CITY OF ALBUQUERQUE

Site: Kiddie Academy – C12E004
4590 Paradise Blvd NW

Re: Drainage Ordinance (14-5-2-1) Violations

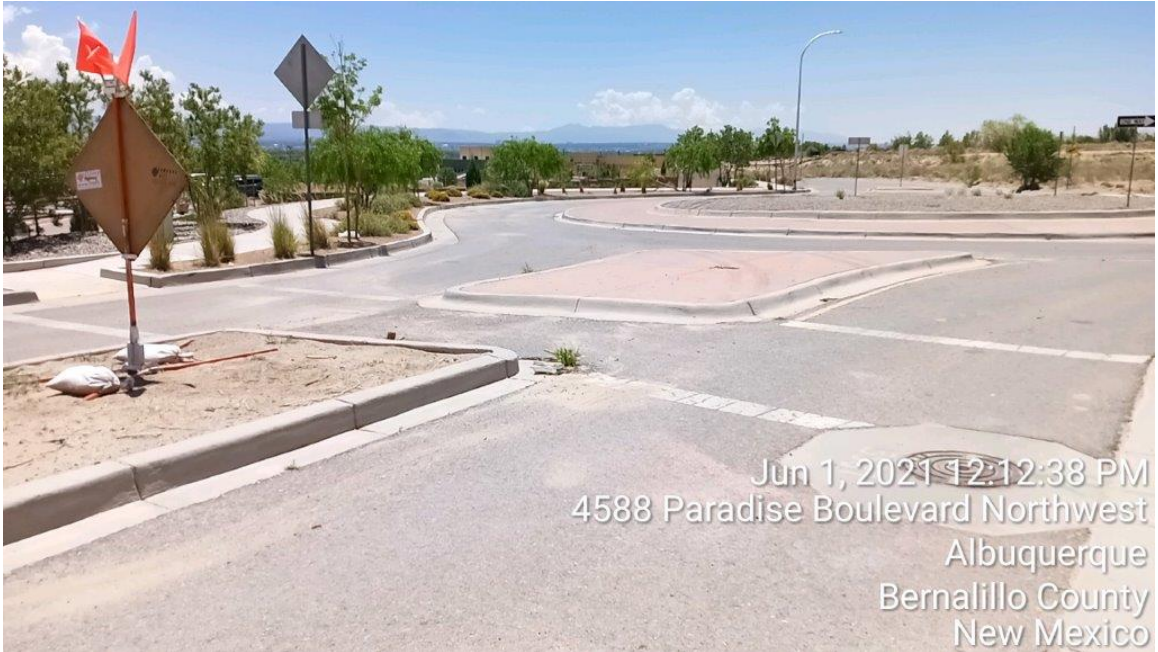
1. The up-to-date SWPPP was not available on-site (1st Violation notice).
2. Self-inspection and corrective action reports were requested and not received (1st Violation notice).
3. BMPs - Silt Fence (2nd Violation notice) holes in silt fence southeast corner of the site still not repaired.

4. Sediment and rasping were washed onto the sidewalk and street during the rain on 5/31/2021. (3rd Violation notice)

3. Ensure that all stormwater controls (BMPs) are maintained and remain in effective operating condition during permit coverage per CGP 2.1.4. If at any time you find that a stormwater control needs routine maintenance, you must immediately initiate the needed maintenance work and complete such work by the close of the next business day. When the problem requires a new or replacement control or significant repair, install the new or modified control and make it operational, or complete the repair, by no later than seven (7) calendar days from the time of discovery per CGP 5.

4. Where sediment has been tracked out from your site onto paved roads and sidewalks, remove the deposited sediment by the end of the same business day CGP 2.2.4.d.

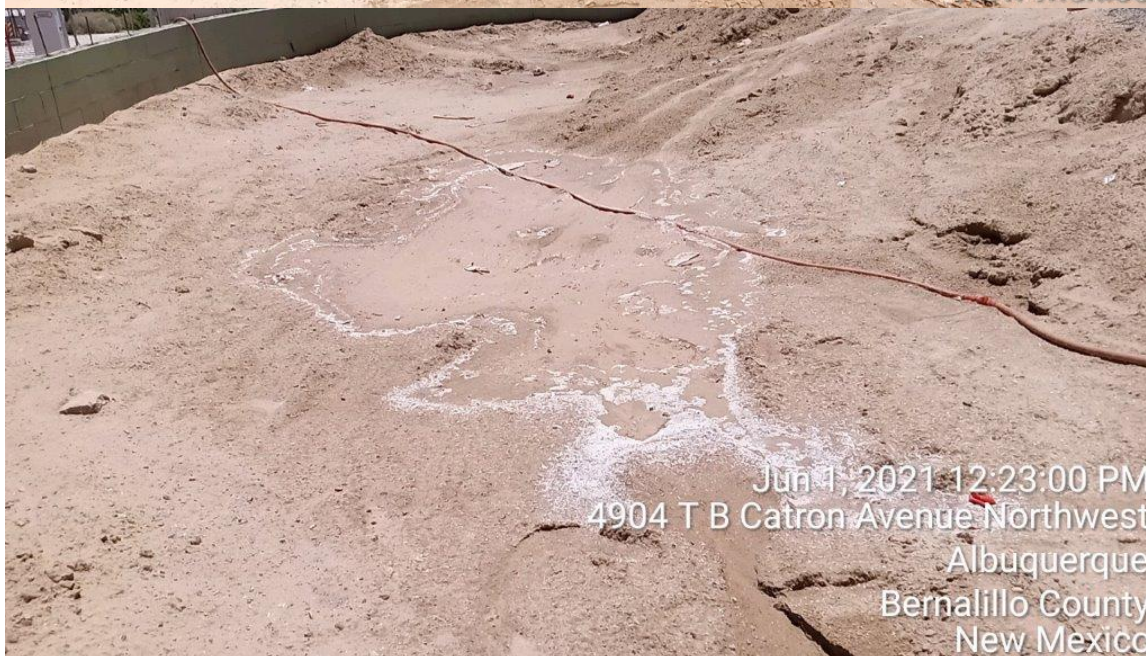
5. Styrofoam rasping (2nd Violation notice) is still on the ground and must be cleaned up daily with the rest of the construction waste. Tarps and vacuum were not in use.

5. Prevent polystyrene rasping and other wastes from leaving the site. On business days, **clean up and dispose of construction and domestic waste** in designated waste containers per CGP 2.3.3.e.iii. Include good housekeeping procedures to prevent adverse environmental impact of Exterior Insulation Finish Systems (EIFS) rasping in the SWPPP and provide copies. Core Safety Group solutions include:

- a. Enclosing scaffolding with netting to help contain Styrofoam fines and prevent transport via wind drift,
 - b. Housekeeping measures, including periodic vacuuming of foam particles that fall to the ground or drift out of the containment netting.

- c. Inspections of nearby areas and housekeeping as needed to reduce off-site impact.

There are commercially available rasping tools with vacuum attachments available for use. **Control rasping at the source. Contain the work area and vacuum.**
